West Winder Bypass
CSSTP-0006-00(327), P.I. No. 0006327
Barrow County

Value Engineering Study Report

April 2010

DESCRIPTION: **REVISE THE ALIGNMENT OF MATTHEWS SCHOOL ROAD
 TO CONNECT TO SR 8 CLOSE TO THE EXISTING
 CONNECTION**

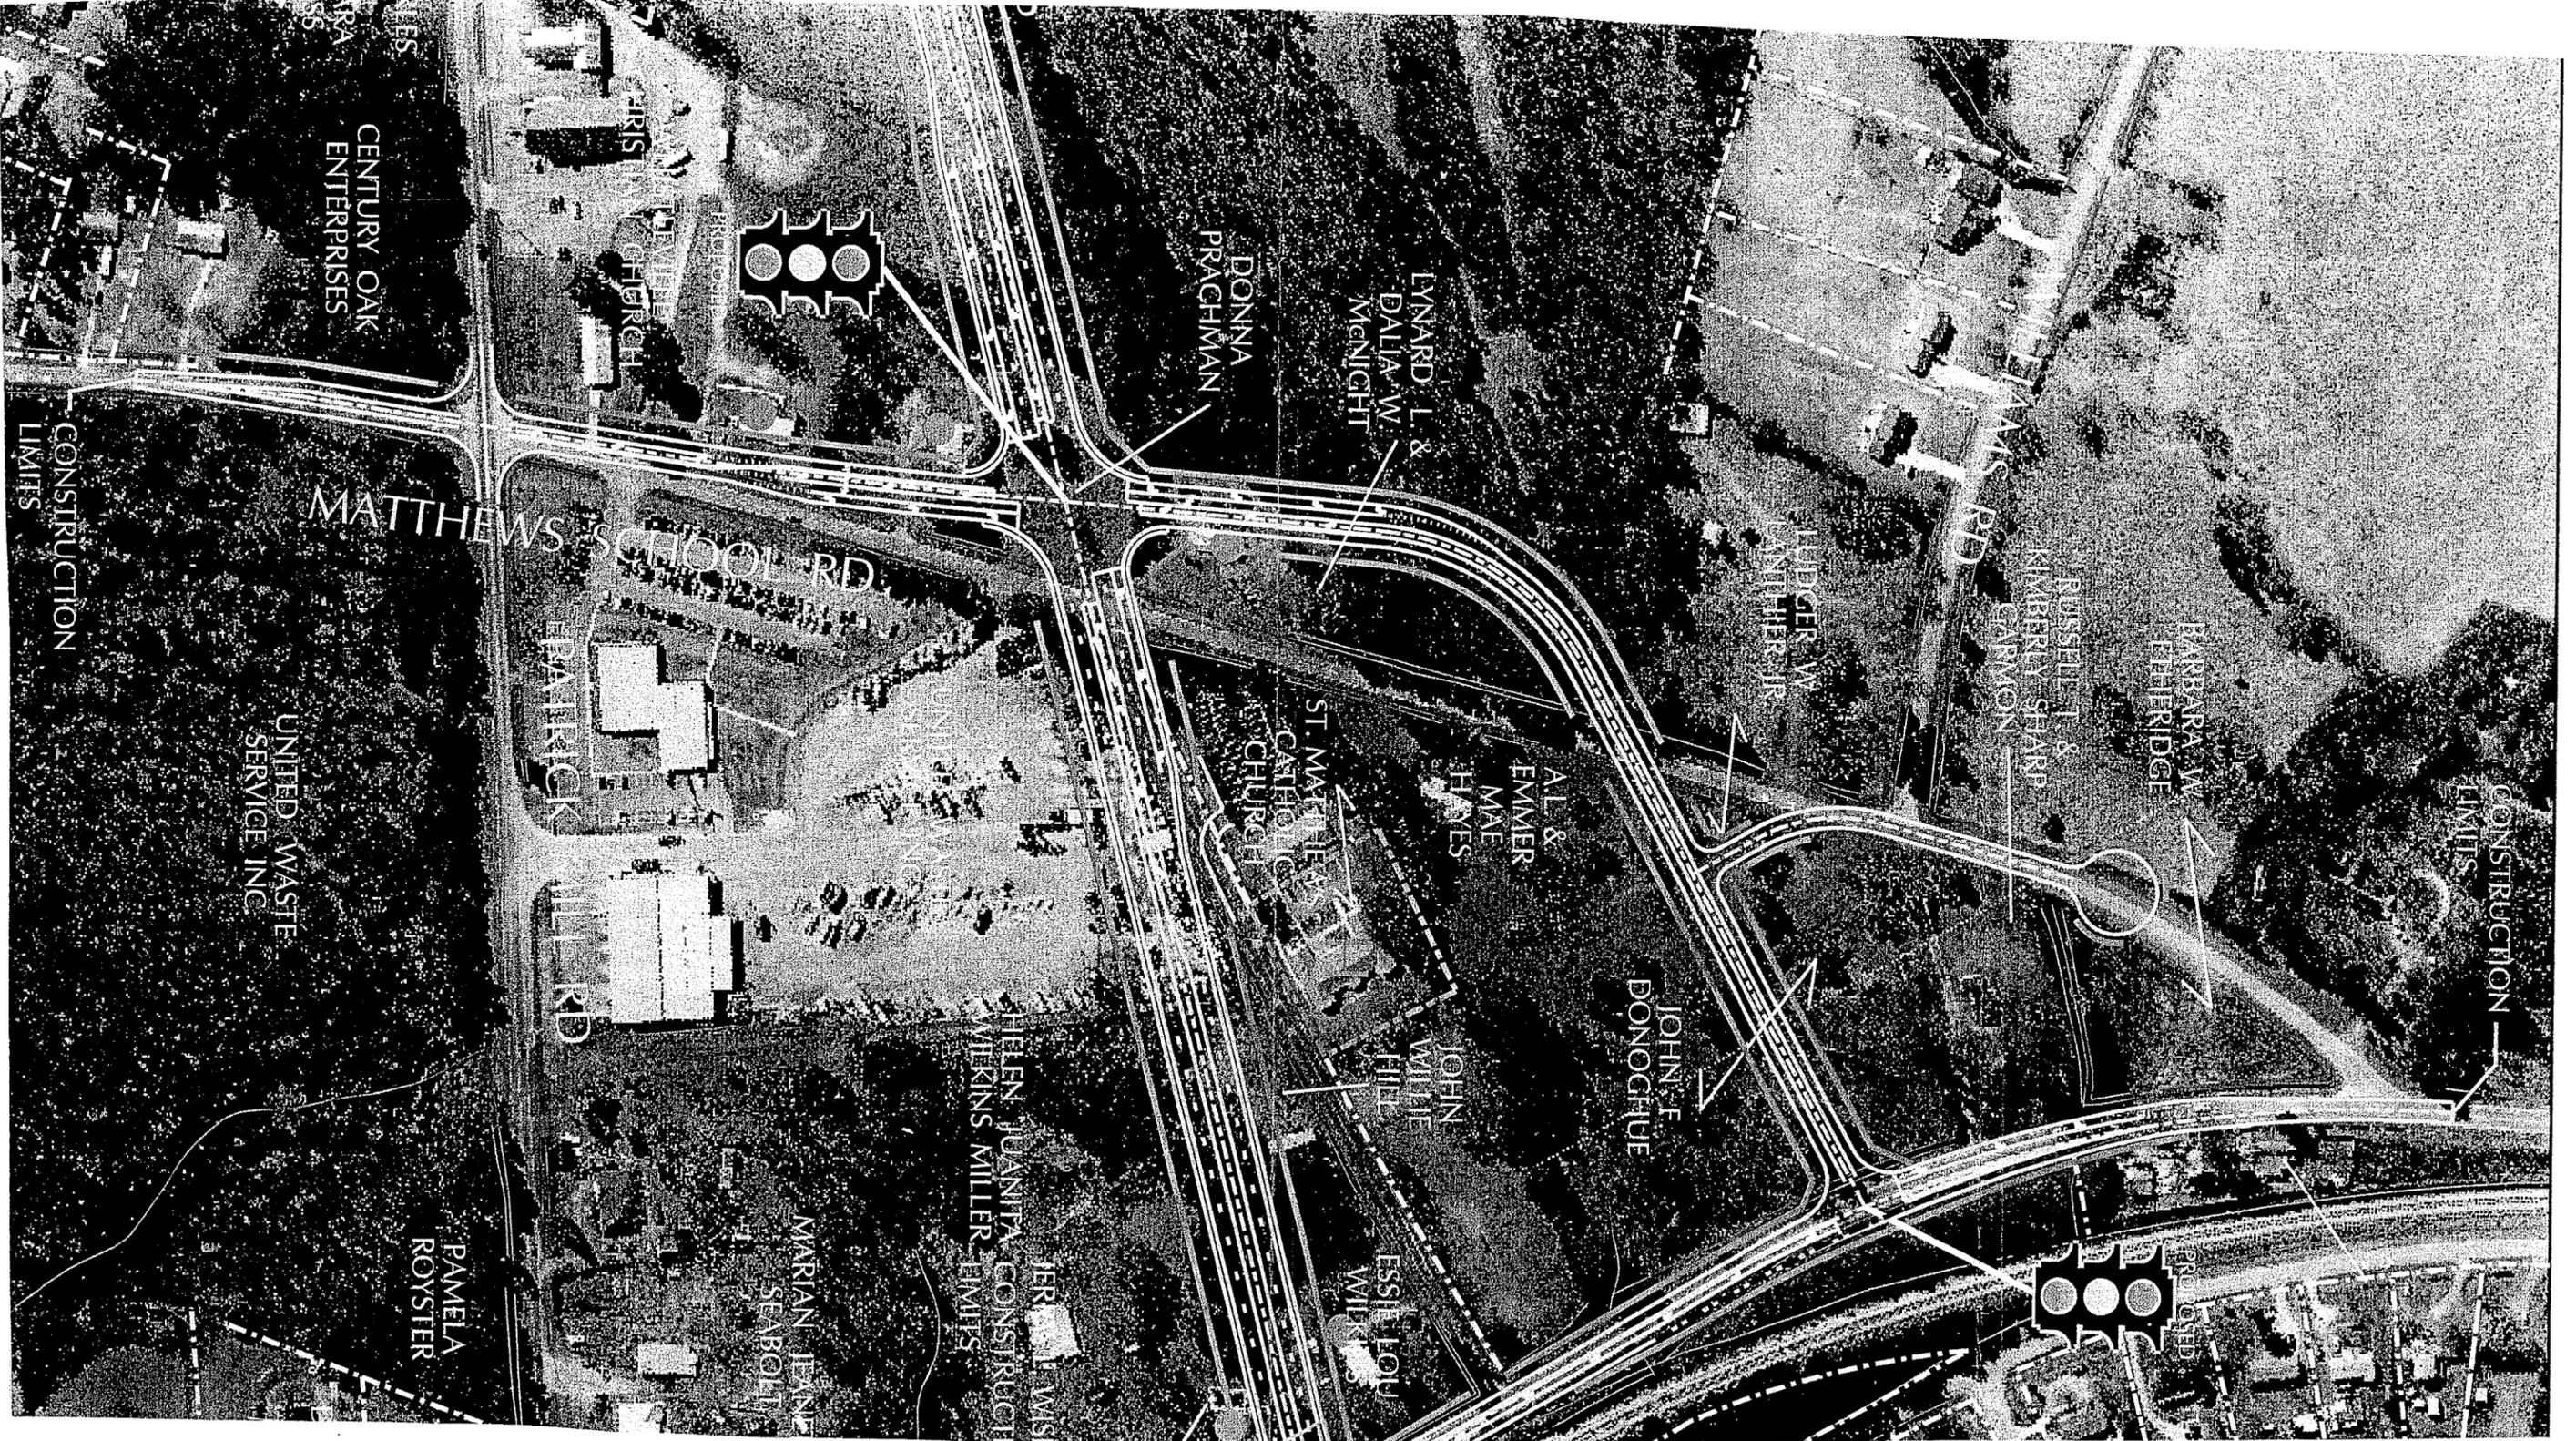
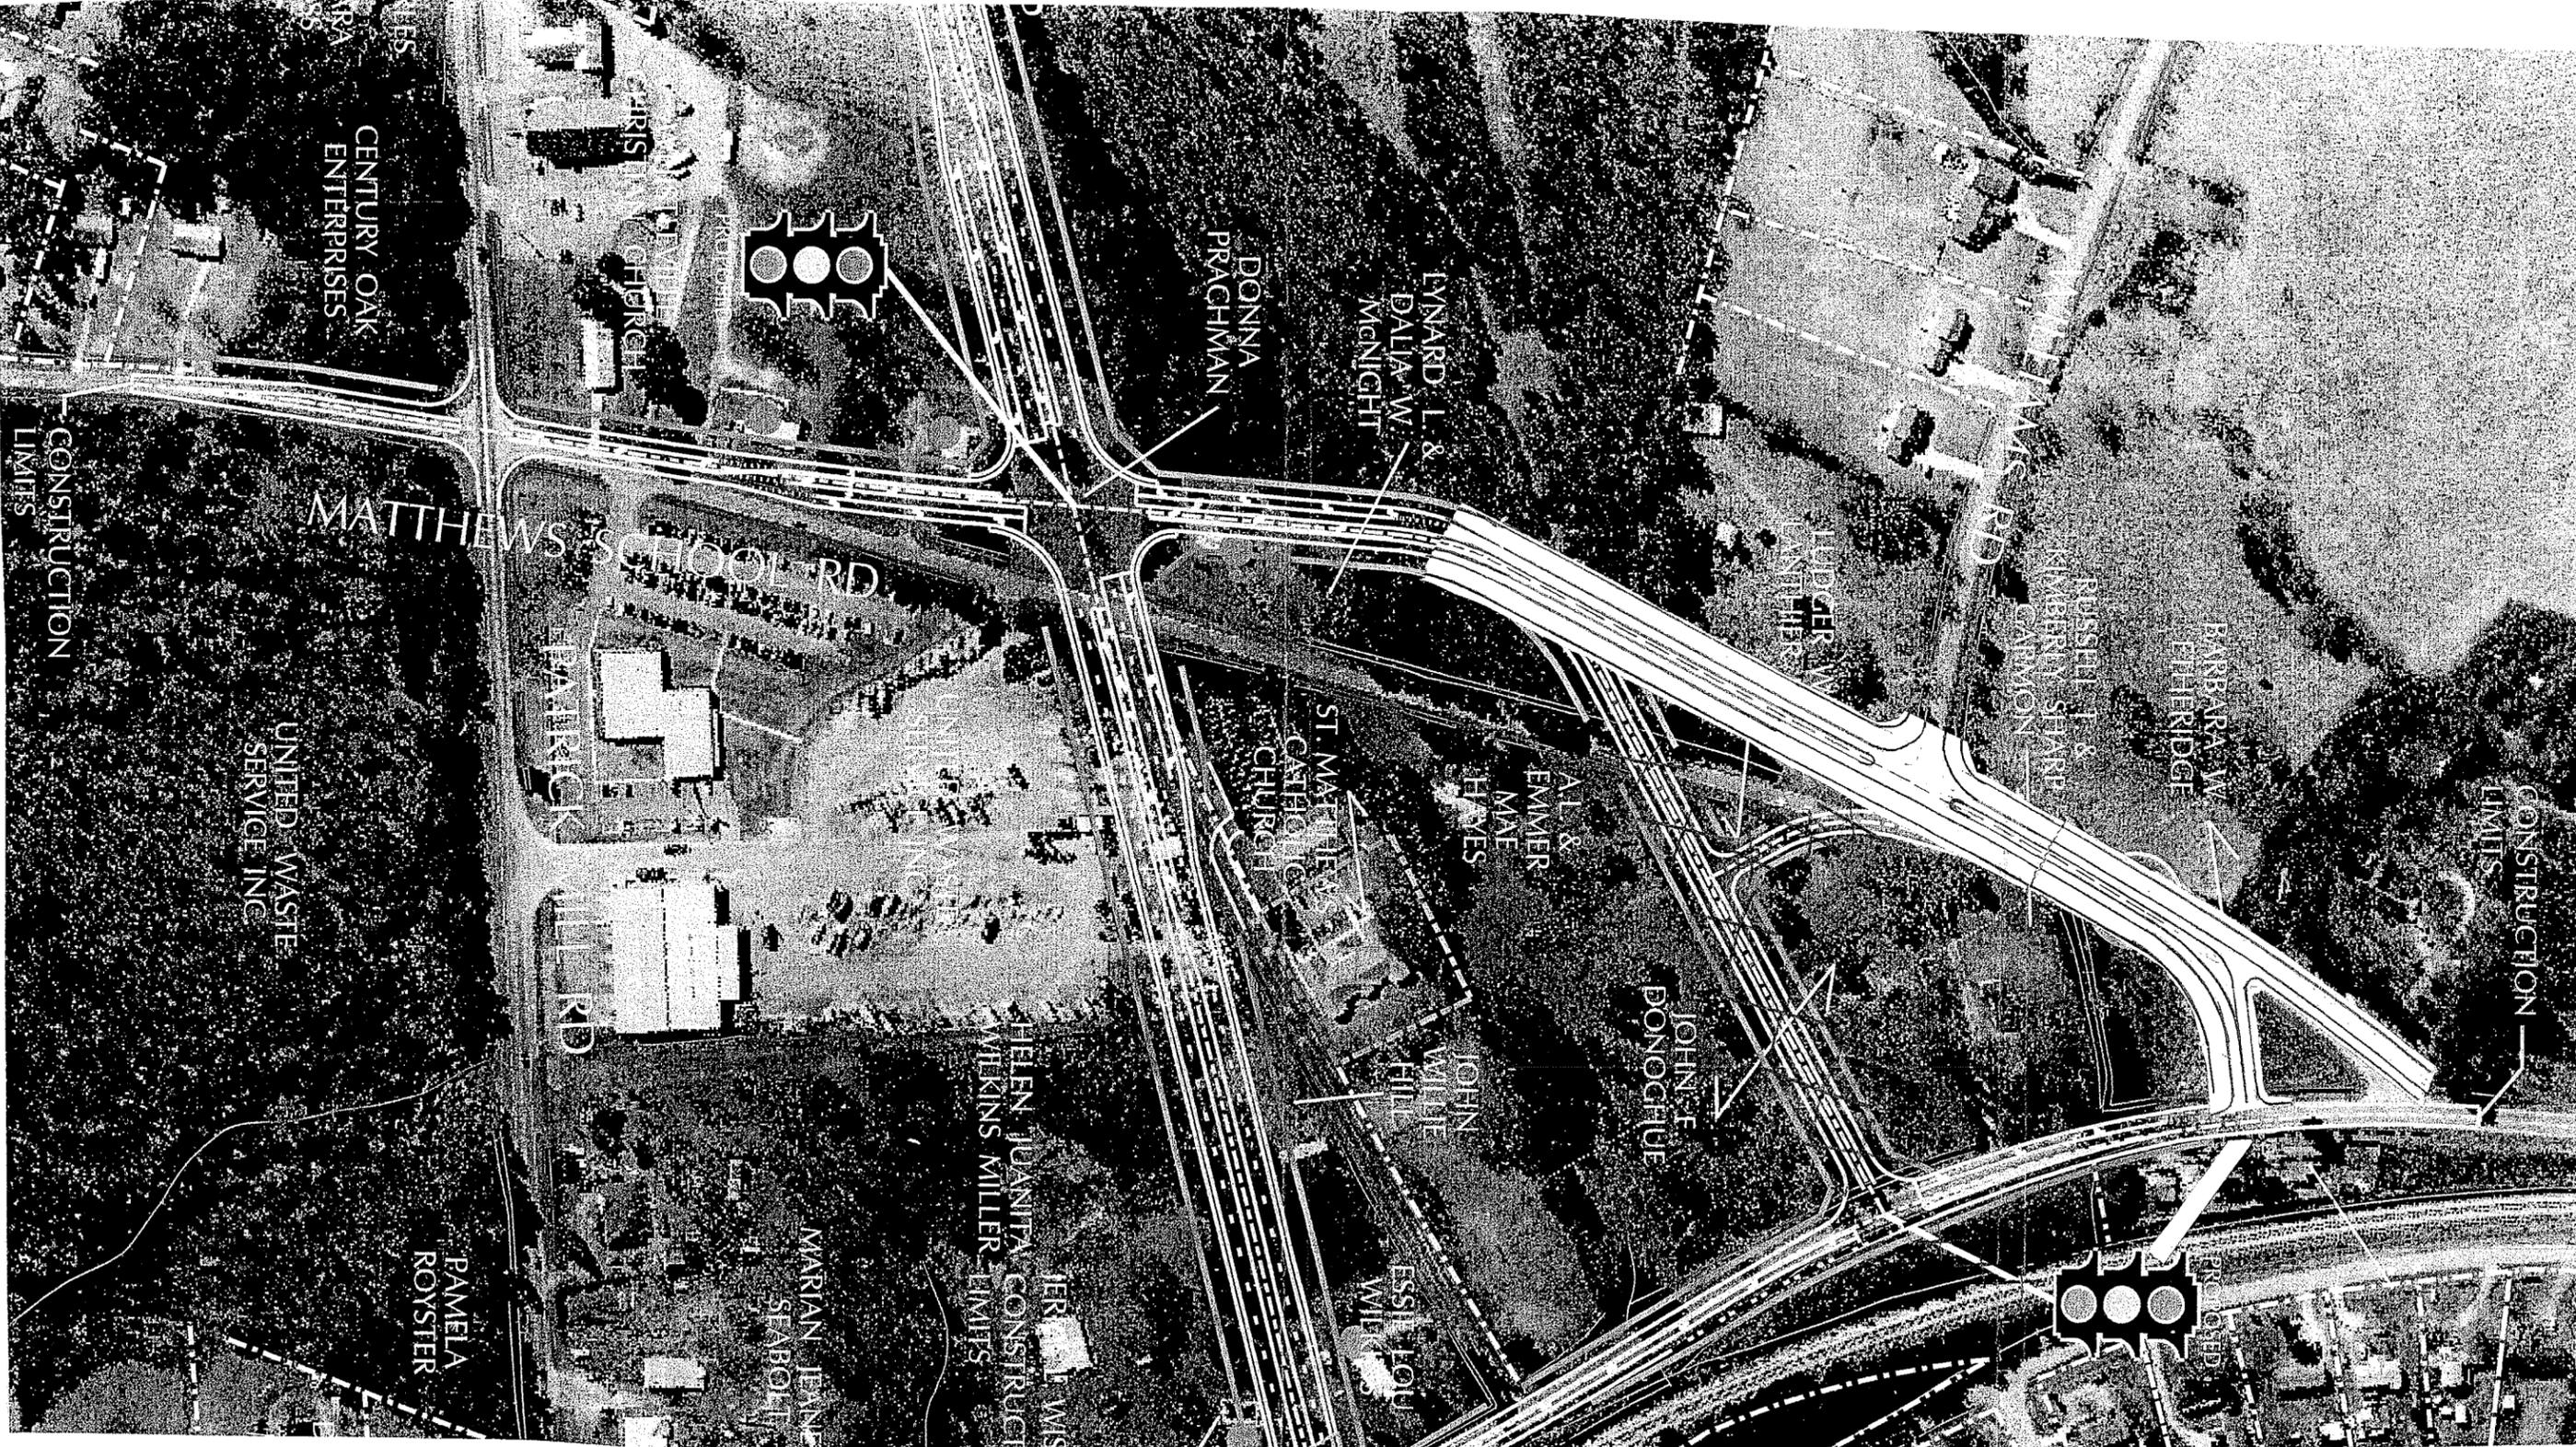
This alternative takes advantage of existing Matthews School Road to avoid having to acquire land from two owners and build part of the new road on new right-of-way. An analysis of the traffic may make it advantageous to eliminate the direct eastbound connection from SR 8 to Matthews School Road.

SR 316 RAMPS

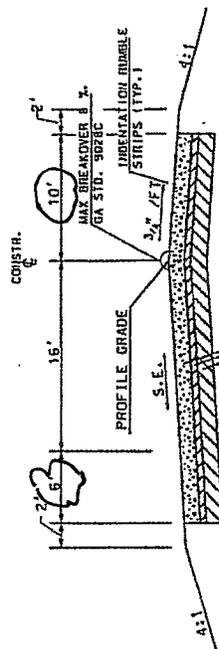
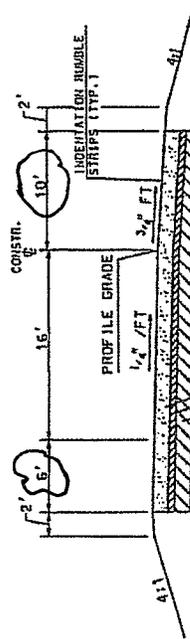
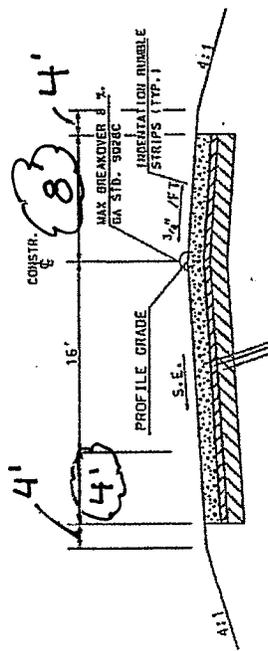
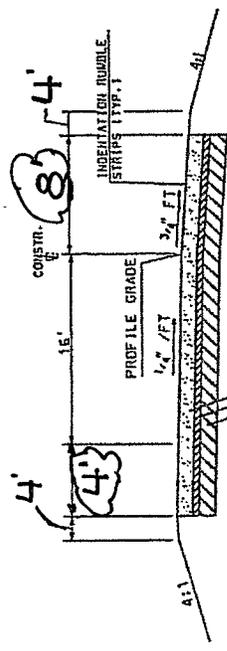
- The ramp traveled-way widths from Exhibit 10-67 for Case II and Case III should be modified when paved shoulders are provided on the ramp. The ramp traveled-way width for Case II should be reduced by the total width of both right and left shoulders. However, in no case should the ramp traveled-way width be less than needed for Case I. For example, with condition C and a 125-m [400-ft] radius, the Case II ramp traveled-way width without shoulders is 6.4 m [21 ft]. If a 0.6-m [2-ft] left shoulder and a 2.4-m [8-ft] right shoulder are provided, the minimum ramp traveled-way width should be 4.8 m [15 ft].

ALTERNATIVE NO.:
18
 SHEET NO.: 2 of 4

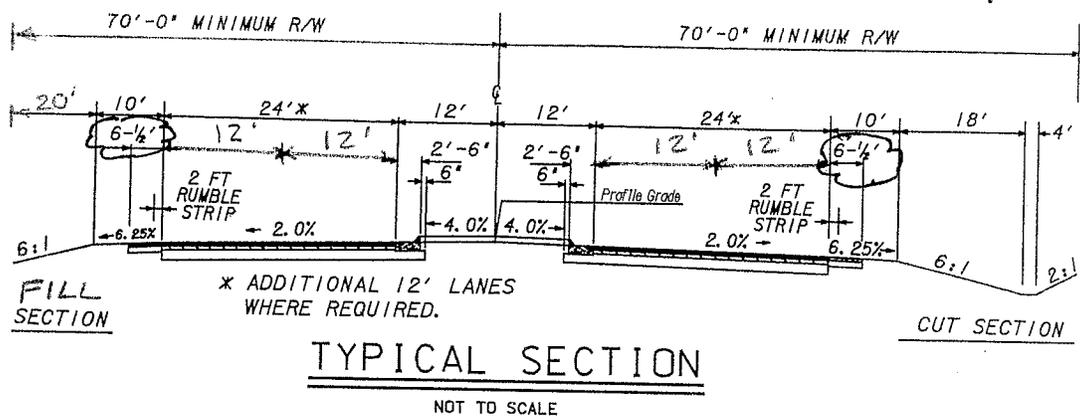
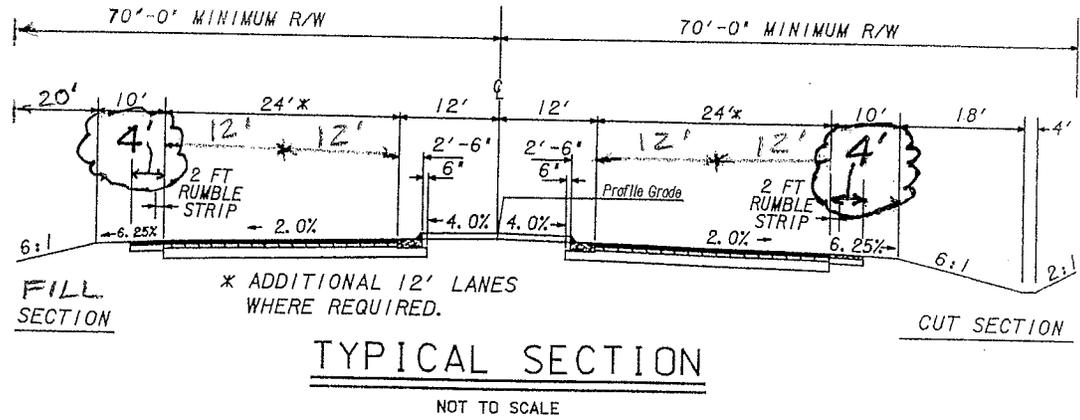
Original Design (6.5' Paved Shoulder)

(4' Paved Shoulder) Alternate Design
